LAND USE REVIEW RESULTS AND COMMENTS

DATE OF COMMENTS: **July 16, 2019**
CASE MANAGER: **Sloane Walbert**
PROJECT NAME: **PONDEROSA COMMUNITY STABILIZATION PROGRAM**
LOCATION: **4475 BROADWAY**
REVIEW TYPE: **Site Review**
REVIEW NUMBER: **LUR2019-00015**
APPLICANT: **DANICA POWELL**
KURT FIRNHABER, CITY OF BOULDER
DESCRIPTION: **Site Review in association with the annexation and initial zoning for the Ponderosa Mobile Home.**

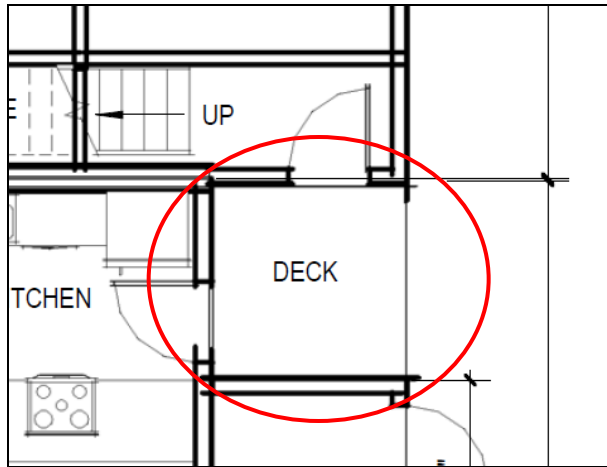
1. The applicant's response does not address staff's comment regarding the proposed Cherry Ave / 10th Ave / 10th Street intersection. Staff does not concur with eliminating the on-street parking, the landscape planting area and attaching the sidewalk at the intersection. Please contact staff in order to resolve this comment and identify the right-of-way dedication requirements on the north side of Cherry Avenue adjacent to the site.
